Project Addresses: 4303 Portage Road
Application Type: Demolition Permit, Zoning Map Amendment, and Conditional Use
Legistar File ID # [86025](#), [84607](#) and [84010](#)
Prepared By: Chris Wells, Planning Division
Report includes comments from other City agencies, as noted
Reviewed By: Kevin Firchow, Planning Division

Proposal Summary: The applicant is seeking approvals to construct a three-story, 65-unit apartment building following the demolition of a single-family residence on the site.

Image 1: Exhibit Showing the Extension of the Public Improvements as part of the Developer’s Agreement for the project known as 4205 Portage Road CSM Phase 1 (Contract No. 9310, Project No. 14637) (from Legistar File [79423](#))

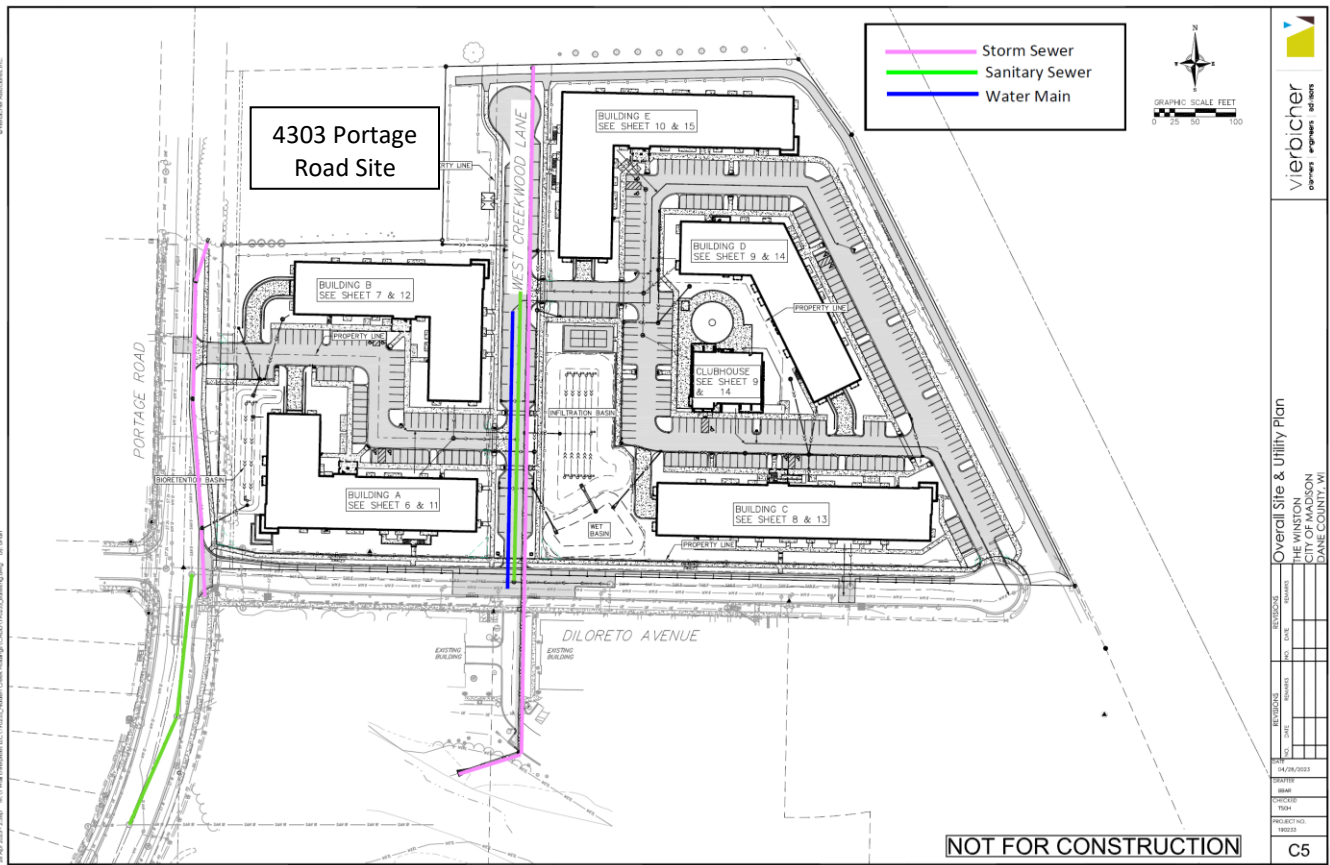
Standard 5 states, "*Adequate utilities, access roads, drainage, internal circulation improvements for pedestrians, bicyclists, public transit and vehicles, parking supply (in cases with minimum parking requirements) and other necessary site improvements have been or are being provided.*" Staff note that Engineering has submitted a condition of approval stating "*This development is contingent on the extension of the public improvements (storm sewer, sanitary sewer, and water) as outlined in the Developer's Agreement (Private Contract No. 9310) for the project known as 4205 Portage Road CSM Phase 1, which was approved by the Board of Public Works on 8/23/2023 and Council on 9/5/2023 (via Resolution RES-23-00550) (Legistar File [79423](#)).*" Staff note that the applicant is the same developer as for the large development (483 apartments in five buildings with pool and clubhouse) directly adjacent to the south and east at 4205 Portage Road (Legistar File IDs [73382](#) and [73801](#)) which was approved in January of 2023. The proposed building at 4303 Portage Road is reliant on the extension of the public utilities as noted in the Developer's Agreement described in Engineering's condition (see Image 1 below). With this project the applicant will be required to enter into an additional Developer's Agreement to further extend the utilities further north in order to serve the proposed building at 4303 Portage Road.

Staff believe Approval Standard 5 can be found met given the formal agreement in place to ensure that the public improvements (utilities) will be extended north to allow the proposed building to connect to them.
